## Post-debugging notes:

D
ı	Sheet: /			
	File: PEEKbot_APS.kicad_sch			
I	tle:			
ĺ	Size: USLetter Date:		Rev:	
İ	KiCad E.D.A. 8.0.1-rc1		ld: 1/2	
_	4	5

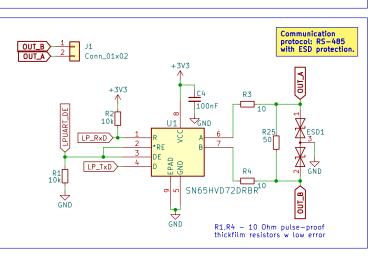
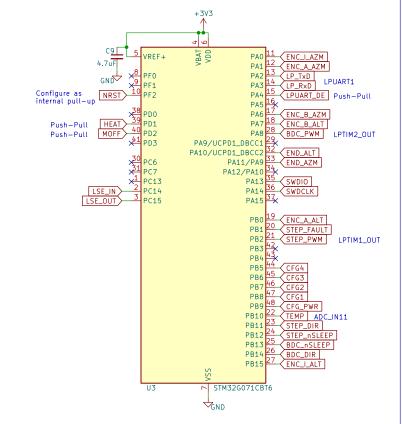
- Hall effect latches are used, which means the HIGH signal holds until the sensor senses a source of magnetic flux with the opposite direction. Find a "switch" instead (Texas Instruments have those too).
- The encoders are open—drain output and the MCU's internal pull—up resistors might be too large for higher speeds, add external circuitry to accommodate this if needed.
- All connection pads and header pins should be replaced with JST connectors for assembly convenience and reliability.
- Encoder input pins on the MCU are selected incorrectly. Either rewire the encoders accordingly, or fix the circuit and reroute the pins. Consult STM32CubeIDE's setup GUI to configurate proper pinout.
